RE: RE-ZONING AND DEVELOPMENT PERMIT APPLICATION: 1042-1044 RICHARDSON STREET

Attn: City of Victoria Planning staff (Alec Johnston):

Responses and actions taken in response to the review are addressed to each individual department in this letter, in the same order that they were presented to the applicant in the Application Review Summary (Dated October 20, 2020 and January 25, 2021). In addition to these responses, and revisions to plans, the following supplementary documents have been produced and are included in re-submission:

4 Solar Study - Summer Solstice 3pm
 1 : 500

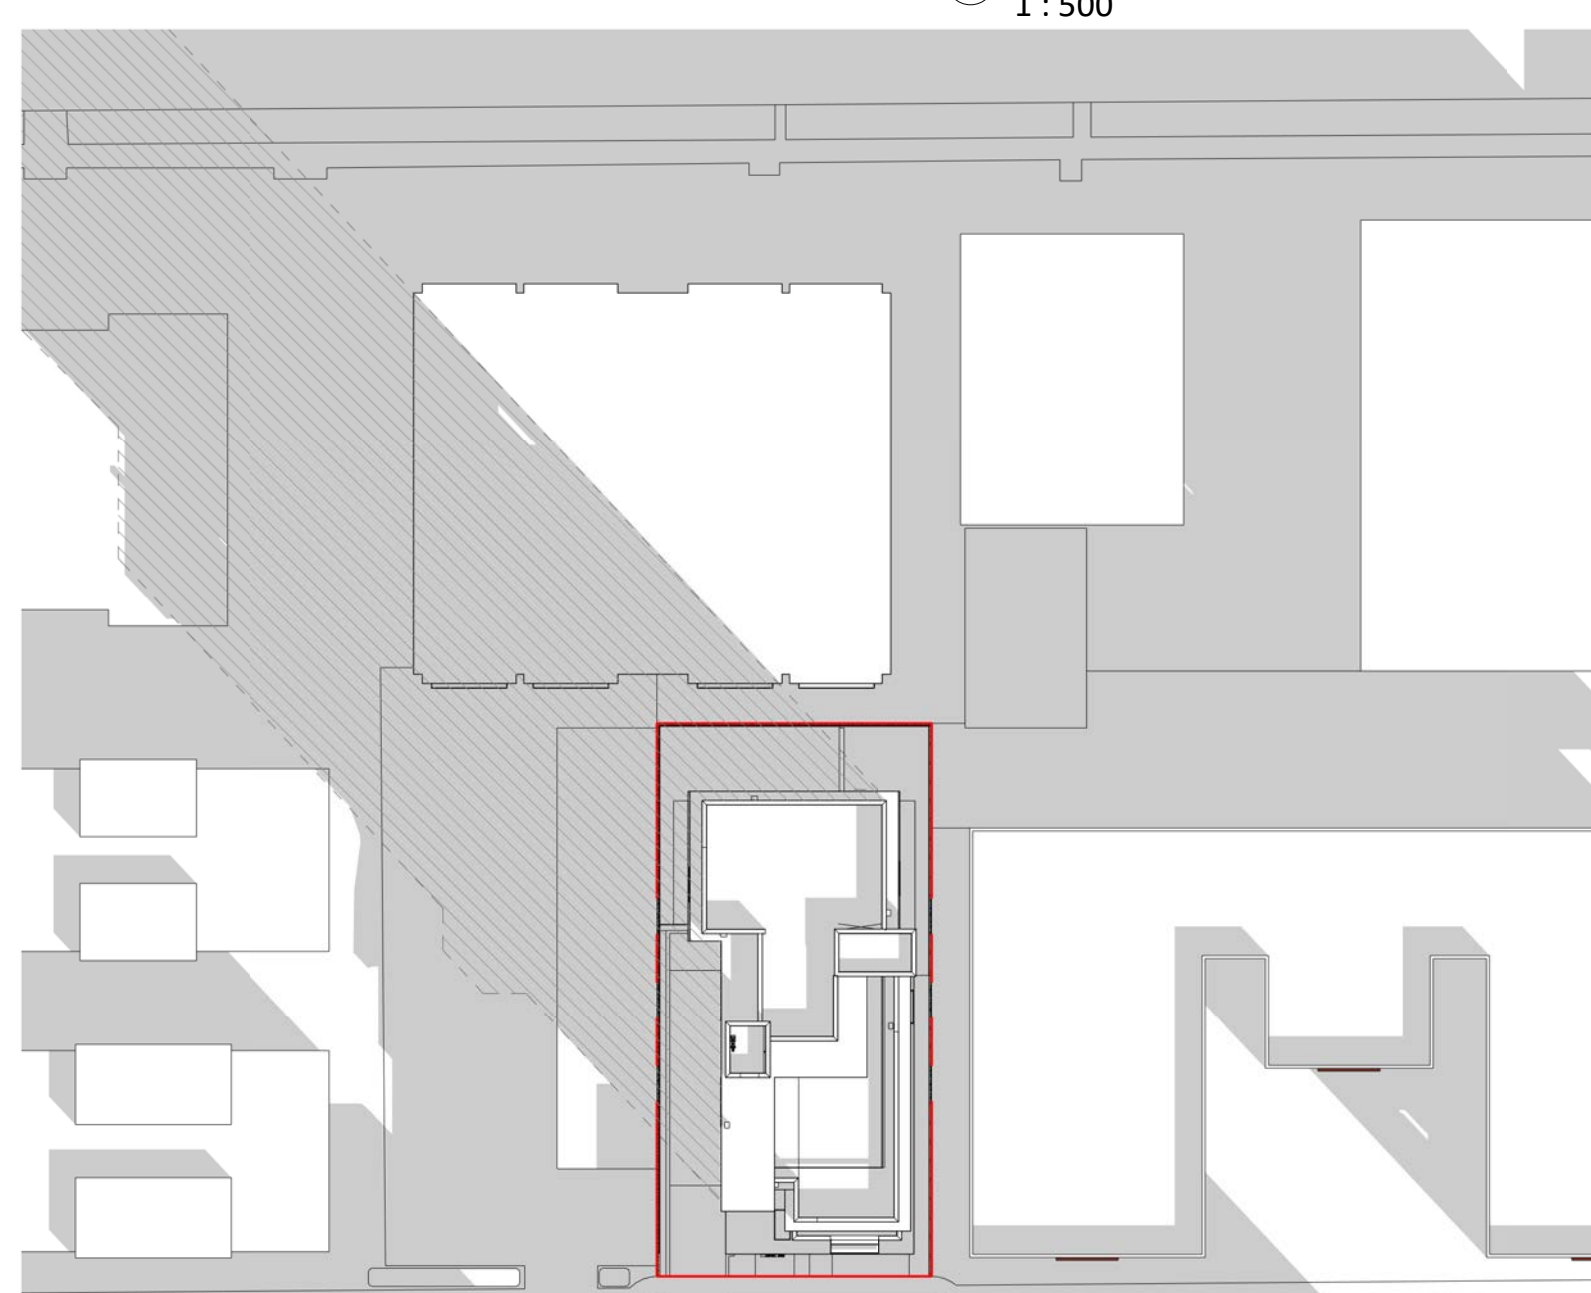
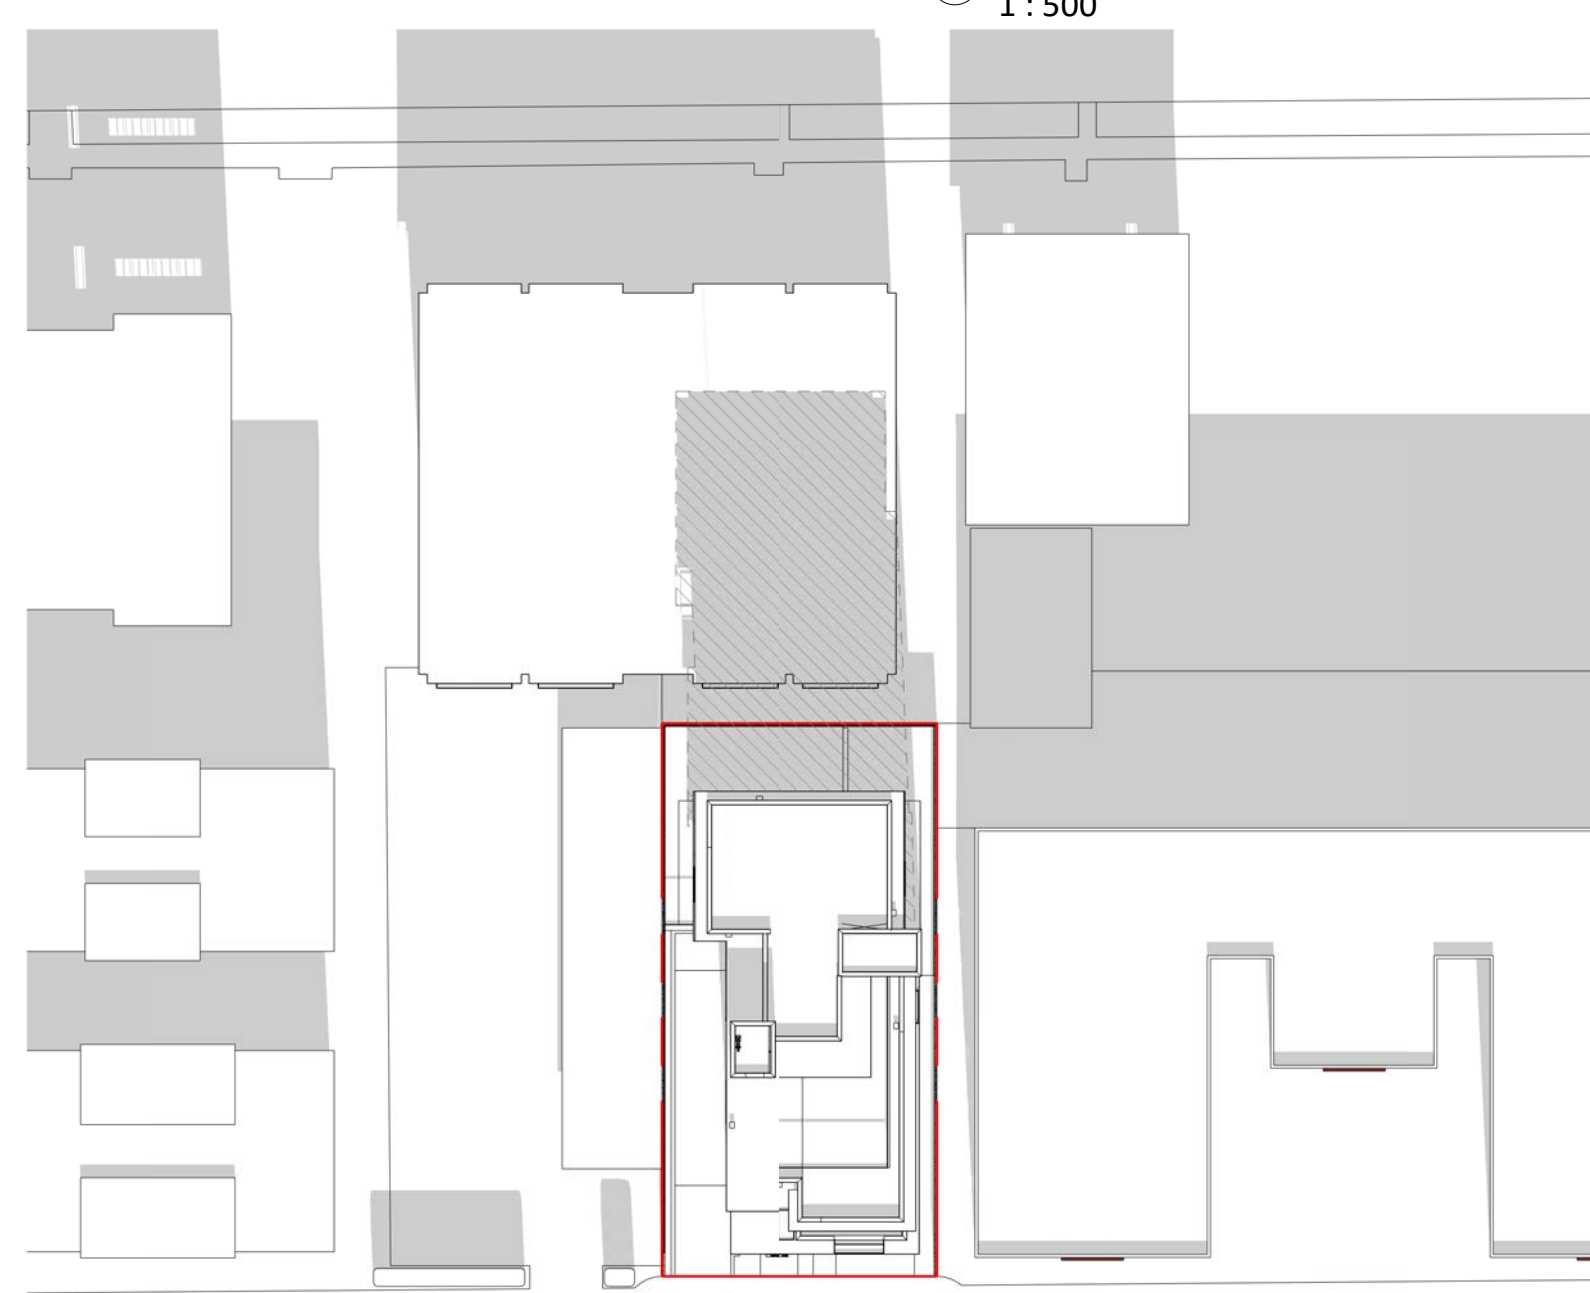
Condition #4: *Please provide a 3D shadow analysis to help assess the shadowing impacts of the proposed building.*

Applicant Response / Actions Taken: A 3D shadow analysis has been completed and is included in the revised plan set. Placing the roof deck centered on the rooftop, and away from the northern property line, reduces shadowing impacts on neighbouring properties.

Figure 4: Proposed Landscape Plan

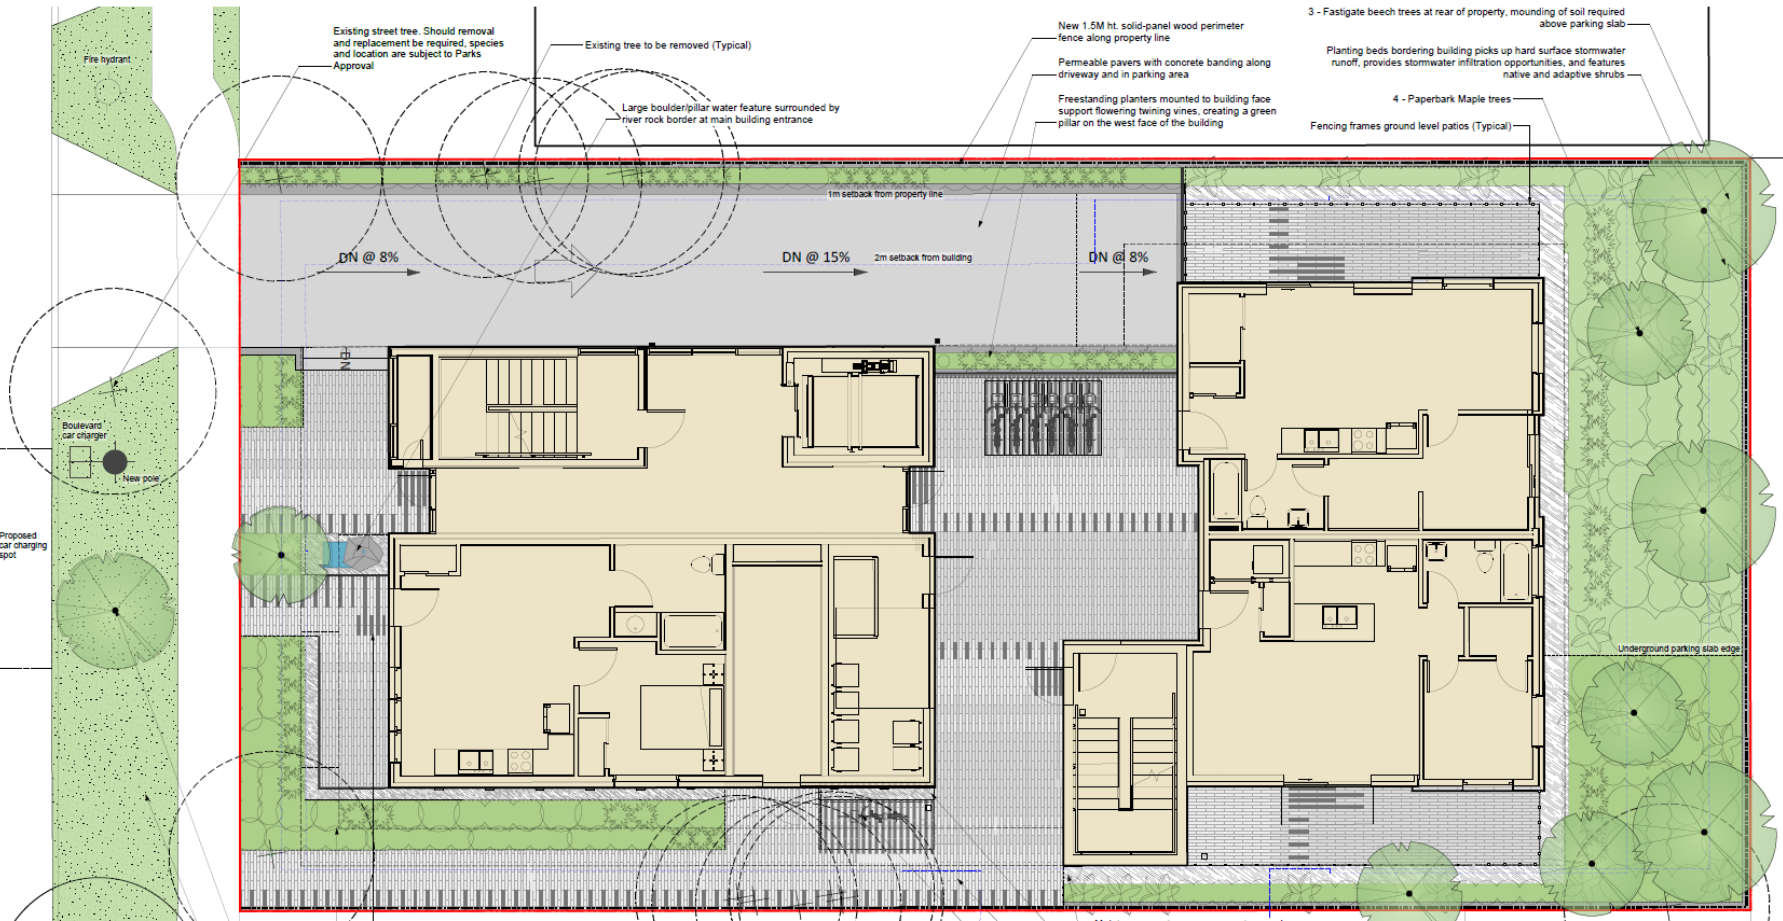
- *For each bylaw protected tree proposed for removal, two Replacement Trees are required and shall be designated on the Landscape Plan. Note that planting locations, species selection, and the number of Replacement Trees that can be accommodated on the lot is subject to approval by Parks.*

- Six Replacement trees are now included in the revised set of plans. See landscape plan for more information on proposed locations and species.
- The proposed street tree location was revised to respect the offsets from infrastructure outlined in Schedule C to Victoria Subdivision and Development Servicing Bylaw.
